Your Ref
APP/15/00516
Our Ref
PLAN-009904
Date
27/05/2015

Proposal: Proposed over flow car park.
Site: Waterlooille Swimming Pool, Waterberry Drive, Waterlooille, PO7 7UW.
APP/15/00516

Southern Water MapGuide Browser

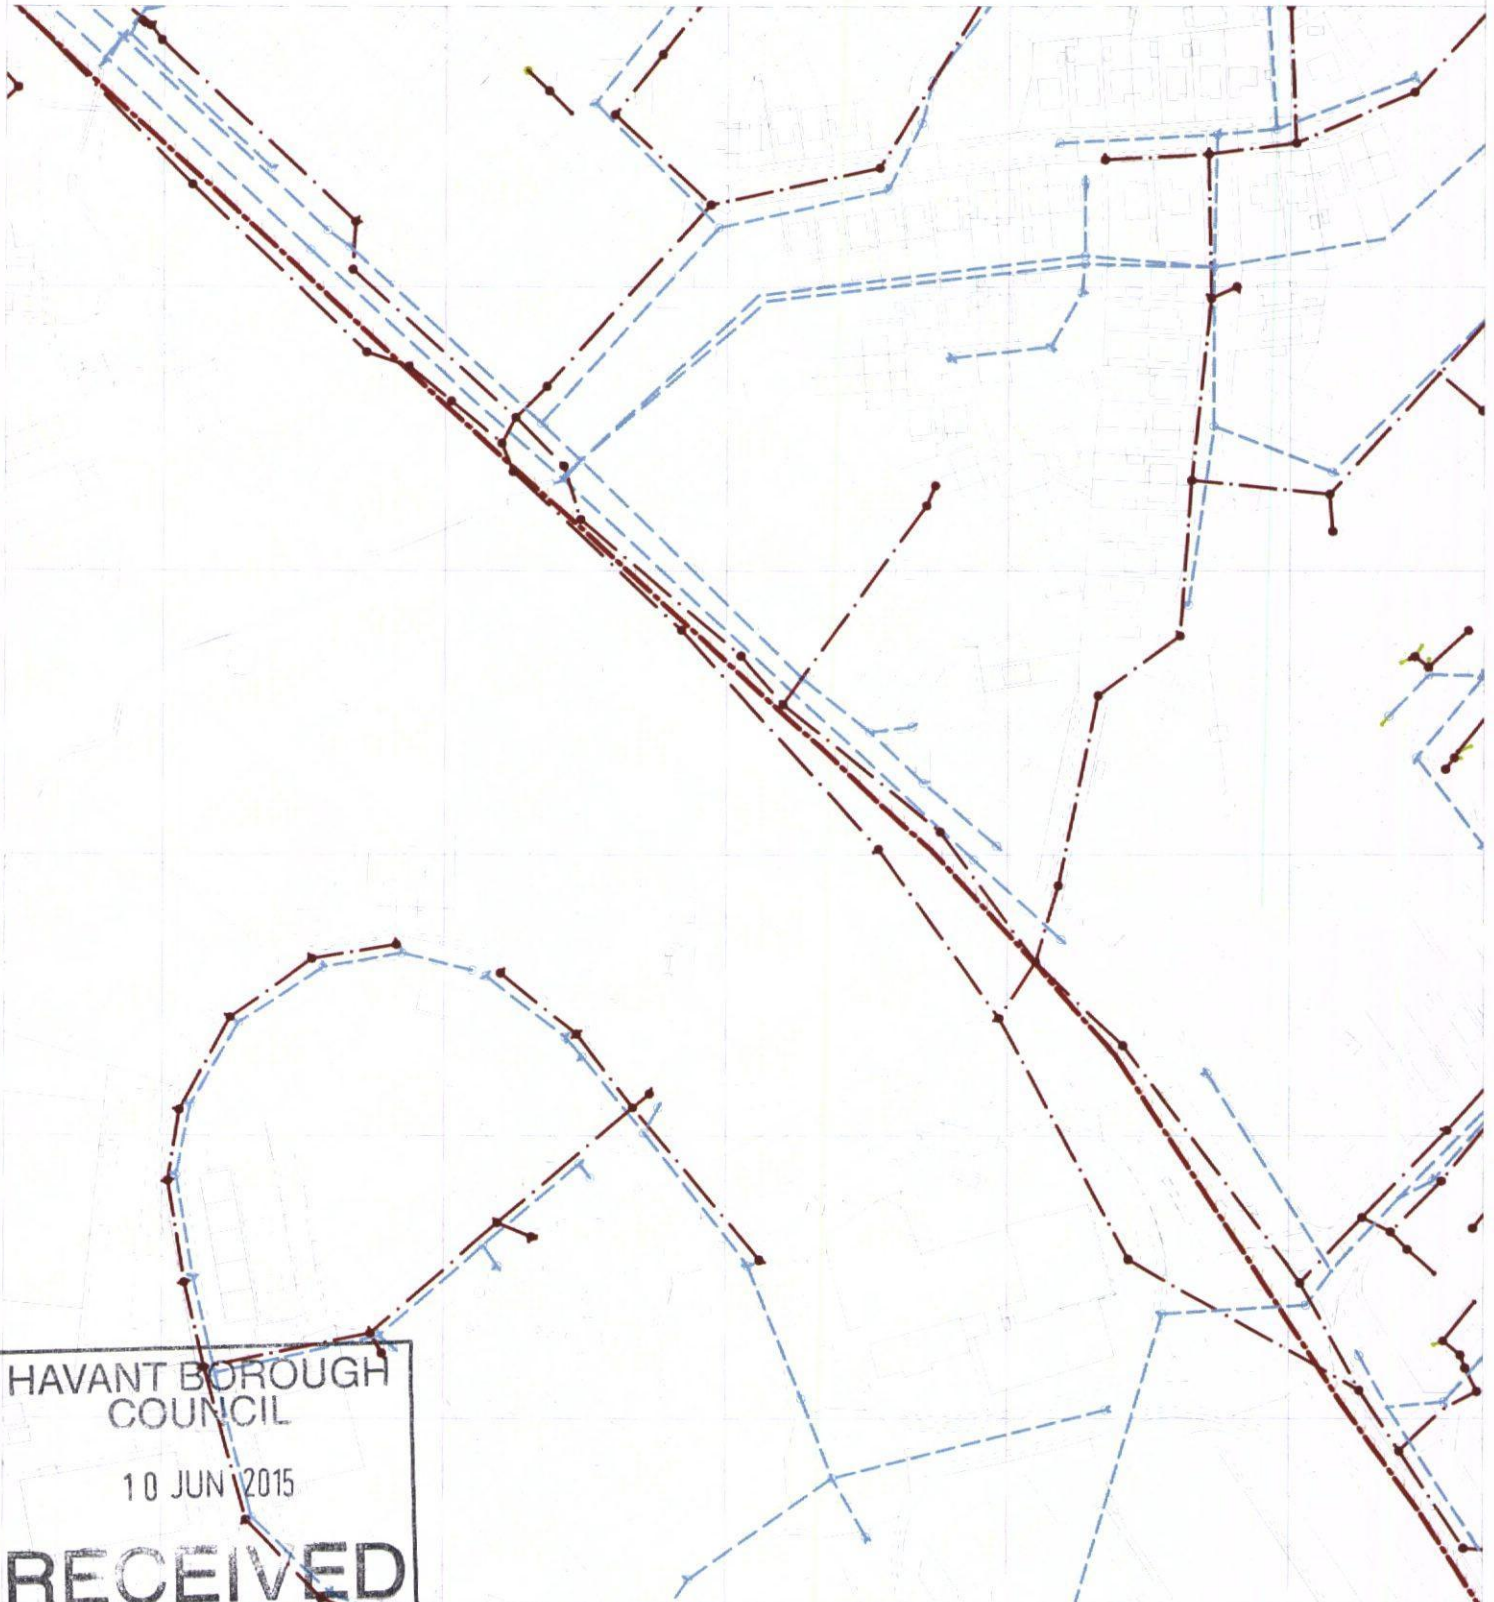
Please find attached a plan of the sewer records showing the approximate position of a public foul rising main, sewer and surface water sewer within the site. The exact position of the public sewers must be determined on site by the applicant before the layout of the proposed works is finalised.

- No development or new tree planting should be located within 3.5 metres either side of the centreline of the public sewer and all existing infrastructure should be protected during the course of construction works.
- No new soakaways should be located within 5 metres of a public sewer.
